# Access Compliance Report

## Public Rights-of-Way

### (Curb Ramps)

Intersection ID: 46305	Main Street: AUGUSTINE_WY	Cross Street: BECKET_RIDGE_RD	Location: NE
ADA ID: 626FFA0B59BF	Ramp Type: PerpDiag	Initial Pass/Fail: Fail	Overall Compliance: No
Severity Score: 33.75			
Codes/Mitigation Info/Possible Solution		Field Measurements/Component Compliance

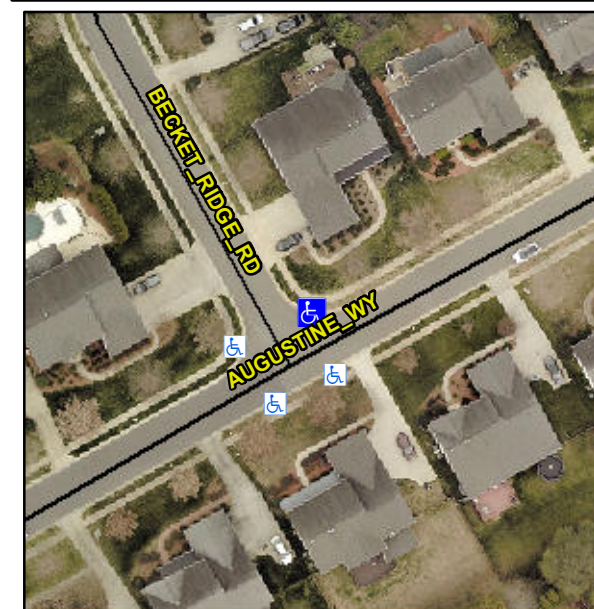
**Not Found, R304.5.1, R304.5.3**

Compliance	Description	Data	Compliance	Description	Data
N/A	Ramp Length (in)	47.0	Yes	Ramp Slope (%)	6.2
No	Ramp Width (in)	39.5	No	Ramp XSlope (%)	7.3
N/A	Flare Type LT	N/A	N/A	Flare Type RT	N/A
N/A	Flare Slope LT (%)	N/A	N/A	Flare Slope RT (%)	N/A
N/A	Flare Traversable LT?	N/A	N/A	Flare Traversable RT?	N/A
N/A	Landing Length (in)	N/A	N/A	DWS Provided?	N/A
N/A	Landing Width (in)	N/A	N/A	DWS Contrast?	N/A
N/A	Landing Slope (%)	N/A	N/A	DWS Length (in)	N/A
N/A	Landing X Slope (%)	N/A	N/A	DWS Full Width?	N/A
N/A	Landing Curb? (Y/N)	N/A	N/A	DWS Offset (in)	N/A
N/A	Shared Landing?	N/A			
N/A	Gutter Ponding?	N/A	N/A	Gutter Slope (%)	N/A
N/A	Gutter Lip Ht (in)	N/A	N/A	Gutter X Slope (%)	N/A
N/A	Painted X Walk1?	No	N/A	Painted X Walk2?	No
	X Walk 1 Direction	To W		X Walk 2 Direction	To S
N/A	X Walk 1 Width (in)	N/A	N/A	X Walk 2 Width (in)	N/A
	X Walk 1 Slope (%)	1.2		X Walk 2 Slope (%)	2.6
	X Walk 1 X Slope (%)	4.0		X Walk 2 X Slope (%)	1.4

**Remove & Replace Curb Ramp With Two New Directional Ramps or Equivalent.**
